Access Compliance Report

Public Rights-of-Way

Intersection ID: 23240	Main Street: SOUTH_COMMERCE_BV	Cross Street: WESTINGHOUSE_BV	Location: E
ADA ID: 31BEF173B042	Ramp Type: PerpDiag	Initial Pass/Fail: Fail	Overall Compliance: No
			Severity Score: 21.25

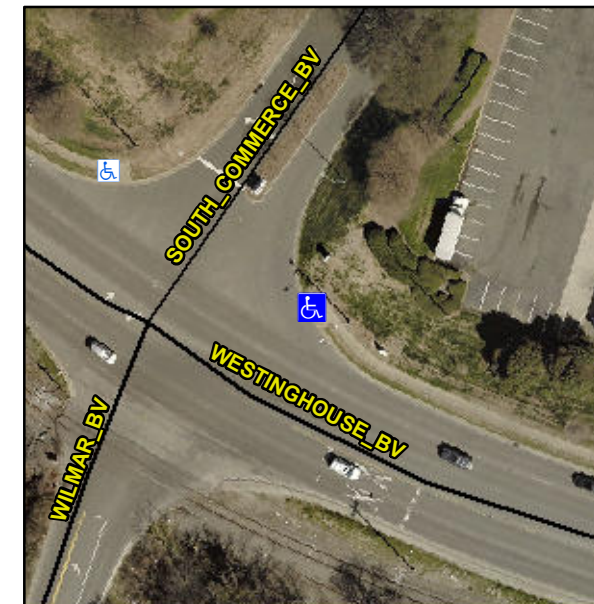
R304.5.1, R304.2.2

Compliance	Description	Data	Compliance	Description	Data
N/A	Ramp Length (in)	111.0	No	Ramp Slope (%)	8.7
No	Ramp Width (in)	45.0	Yes	Ramp XSlope (%)	1.7
N/A	Flare Type LT	N/A	N/A	Flare Type RT	N/A
N/A	Flare Slope LT (%)	N/A	N/A	Flare Slope RT (%)	N/A
N/A	Flare Traversable LT?	N/A	N/A	Flare Traversable RT?	N/A
N/A	Landing Length (in)	N/A	N/A	DWS Provided?	N/A
N/A	Landing Width (in)	N/A	N/A	DWS Contrast?	N/A
N/A	Landing Slope (%)	N/A	N/A	DWS Length (in)	N/A
N/A	Landing X Slope (%)	N/A	N/A	DWS Full Width?	N/A
N/A	Landing Curb? (Y/N)	N/A	N/A	DWS Offset (in)	N/A
N/A	Shared Landing?	N/A			
N/A	Gutter Ponding?	N/A	N/A	Gutter Slope (%)	N/A
N/A	Gutter Lip Ht (in)	N/A	N/A	Gutter X Slope (%)	N/A
N/A	Painted X Walk1?	No	N/A	Painted X Walk2?	No
	X Walk 1 Direction	To NW		X Walk 2 Direction	To SW
N/A	X Walk 1 Width (in)	N/A	N/A	X Walk 2 Width (in)	N/A
	X Walk 1 Slope (%)	0.6		X Walk 2 Slope (%)	1.5
	X Walk 1 X Slope (%)	2.3		X Walk 2 X Slope (%)	0.5

Remove & Replace Curb Ramp With Two New Directional Ramps or Equivalent.
